Technical Bulletin CS-02-03

Hardware Changes to Support the NEC NEAX 2000 IVS²

This technical bulletin provides detailed information on hardware changes required to support the NEC NEAX 2000 IVS²

Figure 2

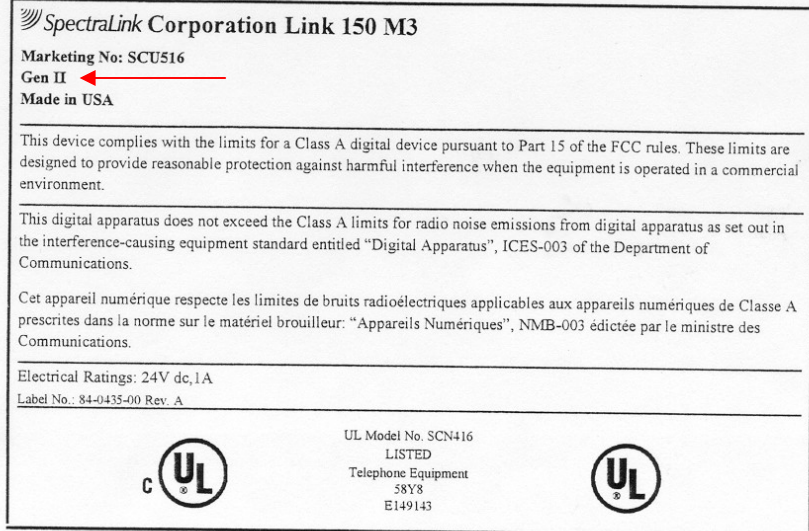
For the Link 150 M3 system, you must use either the new SCU516/508 or SCH516/508 Master Control Units. The product label on the bottom side of the MCU will indicate Gen II (see Figure 2).

Figure 3

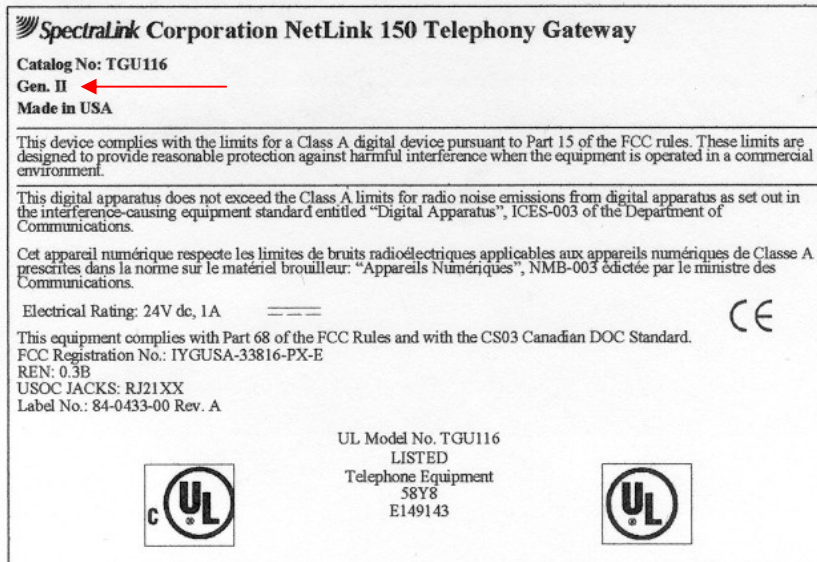
For the NetLink 150 system, you must use either the new TGU116 or TGH116 Gateways. The product label on the bottom side of the Gateway will indicate Gen II (see Figure 3).
